## **Terex Utilities**

# SAFETY NOTICE

**SN681**

**SUBJECT: Leveling Sensor Installation**

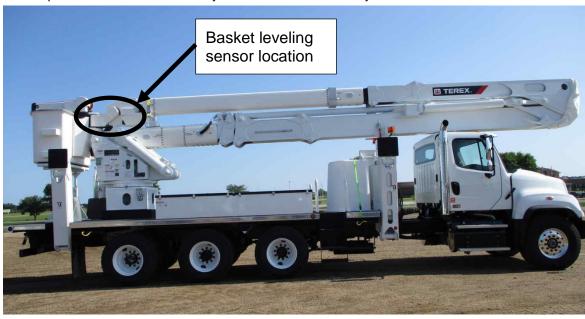
On Terex TM end mount aerial devices, manufactured from April 2014 through July 2019, one of the two basket level limit sensors at the boom tip may have been assembled upside down. The limit sensors prevent the platform from going more than 15 degrees from level if the electrical system malfunctions. The incorrect mounting of the level sensor may cause an out of level basket to continue moving more than 15 degrees out of level. If the leveling system malfunctions it may cause the occupants to fall from the platform.

b. Inspect the basket level sensor orientation using the below pictures for reference.

This bulletin applies if the Light colored potting visible on both sensors

This bulletin does **NOT** apply if the Light colored potting visible on top sensor only

- 3. If your unit has both sensors mounted with the light colored potting visible, this bulletin applies. Correct following the instructions in Field Service Kit Z1562. Take a picture before correcting the issue and another picture after correcting the issue. Send both pictures with the completion form including the serial number and date of correction to utilities.warranty@terex.com.
- 4. If your unit has the light colored potting visible only on the top sensor, and the wires coming out of the sensors below the mounting screw this bulleting does not apply and use can continue without restriction.
